The North Dakota Department of Environmental Quality (NDDEQ) has reviewed your August 4, 2022, letter discussing the Wilton Area Sinkhole Filling Project. It is our understanding that the sinkhole will be filled with materials obtained from a spoils pile located near the sinkhole site.

24 AM-21-143 Filed 08/12/2022 Pages: 2
Response to Advisory letter regarding Wilton sinkhole emergency - electronic only
North Dakota Department of Environmental Quality (DEQ)
Carl Anderson

Wilton Emergency Sinkhole
 TRS: T142N R79W Sec. 6
 Burleigh County

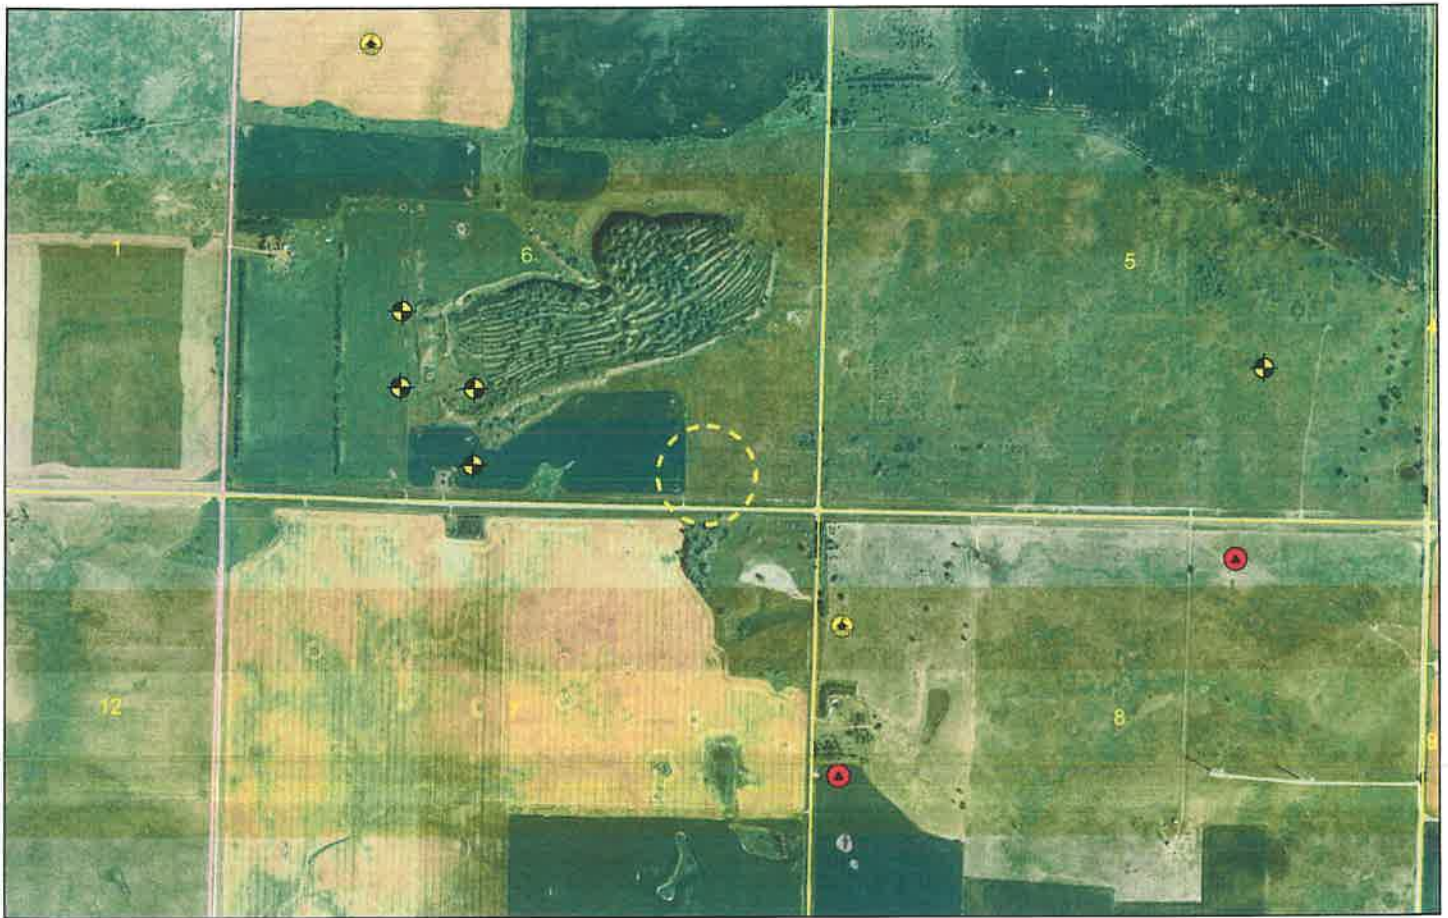
The location of the project area was mapped in relation to wellhead protection areas, glacial drift aquifers, and existing wells (map attached). Although the project site is not located over a defined glacial drift aquifer or within a sensitive groundwater area, there are several wells located in the vicinity of the project site.

We do not object to the proposed sinkhole filling project as long as the fill material does not contain contaminants that could negatively impact groundwater quality. In addition, care should be taken to avoid spills of any materials that may have an adverse effect on groundwater quality. All spills must be immediately reported to this Department and appropriate remedial actions performed.
